THE CORPORATION OF THE TOWN OF COBOURG

Report to:	Mayor and Council Members	Priority:	☐ High ☒ Low
Submitted by:	Dave Johnson Planner II – Heritage Planning and Development Planning djohnson@cobourg.ca	Meeting Type:	Open Session ☒ Closed Session ☐
Meeting Date:	April 7, 2021		
Report No.:	HP-2021-009		
Submit comments to Council

Subject/Title: **Roof Replacement – 212 King Street West – Marie Dressler House (Town of Cobourg)**

Figure 12: 212 King St. W (Dressler House) roof plan – only highlighted areas are to be replaced. Areas B.1 and B.2 have already been replaced with a composite polymer shake style material (see Figure 17).

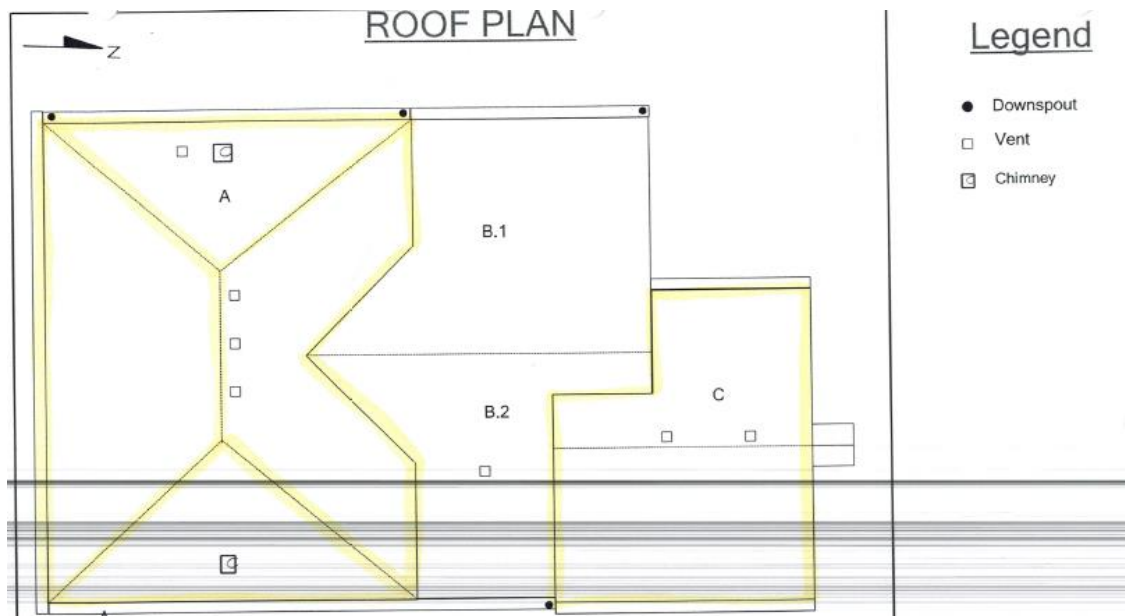
The Town of Cobourg is proposing to replace the current ageing cedar shake roofing system that exists on the front and rear sections of Dressler House as it leaking into the attic (see Figure 12- roof plan below and Figures 13-16). Presently, the Town is proposing a product called "Presidential Shake" which is a fiberglass shingle with the colour to be "weathered wood" (see Figure 17). The new fiberglass shingle is only to replace the existing deteriorated cedar shake shingles on the front primary building and the rear addition (Figure 12). The central portion of the building is currently sheathed with a composite polymer shake material design (see Figure 17). Over the years, it appears that the roofing material on the building has been altered a number of times, including what appears to have been slate, asphalt shingle and cedar wood shake.

While fiberglass shingles are considered a composite roof material, and in shake form could be an appropriate replacement product for Dressler House, Heritage and Planning staff do not recommend having two substantially different roofing materials or designs/textures on a heritage structure (fiberglass and polymer shake). Accordingly, it is recommended that a product similar in design, texture, composition and colour as the existing composite polymer shake product be installed to ensure consistency and uniformity with the balance of the building.

It should be noted that the composite polymer shake on the central portion of the existing Dressler House roof that was installed a number of years ago is no longer available. It is the recommendation of staff that a Davinci composite polymer shake product (or equivalent) be implemented in the colour "Chesapeake" as this appears to be the closest matching design and colour to the existing composite roofing material (see Figures 17-18). Additionally, the roofing contractor has indicated that

In summary, Heritage and Planning staff does not recommend using the proposed fibreglass shingle product to replace the existing deteriorating cedar shakes on the front and rear sections of the building, but rather recommends using a composite polymer shake material by Davinci (or equivalent) in “Chesapeake” colour to more closely match the existing polymer shake currently in use on the central section of the building. Staff’s recommended approach for this polymer shake has been evaluated against the West HCD Plan, specifically the policy relating to roofs (4.2), and it is our opinion that the new roof on the front and rear sections of the building (change from cedar wood shake to a polymer shake) is an acceptable, complementary alteration and would be consistent with the central section that already exists today. The roofline and chimneys, and other defined heritage attributes, are not proposed to be changed as a result of this alteration. The applicant has retained Ontario Roofing as the contractor to undertake the proposed alteration.
